ASHA Consulting (Pty) Ltd

RE: REVISED LAYOUT AND TURBINE SPECIFICATIONS FOR THE NAMAS WIND FARM: HERITAGE OPINION

FACILITY NAMESAHRA CASE NUMBERS:DEA REFERENCE NUMBERSNAMAS WIND FARM:1306414/12/16/3/3/1/1971

The western portion of the Namas Wind Farm showing the farm portions (black polygons), all finds (red numbered symbols) and the amended facility layout (blue lines).

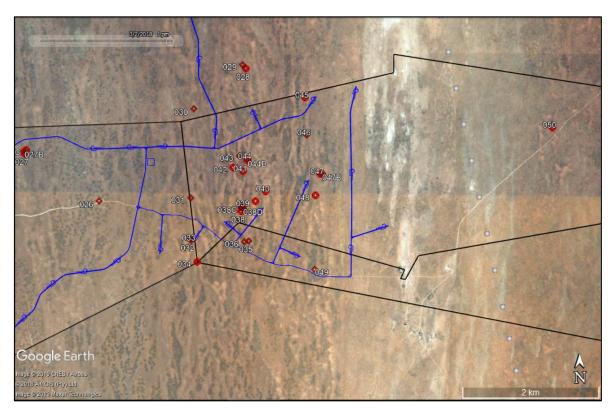
Archaeological sites were found to be distributed variably around the study area with more present on the dune cordon closest to the coast. The flat plains in between the dune cordons tended to have minimal finds.

The amended layout has been devised to avoid all known sites but, although the survey carried out during the EIA aimed to locate as many sites within the study area as possible, it is still possible, indeed likely, that some sites will be intersected. The number, however, should be small. The HIA recommended that a walk down survey should be done pre-construction and this is still suggested for the amended layout.

- An archaeologist should be appointed to conduct a final pre-construction survey of the approved layout at least 6 months prior to commencement of construction;
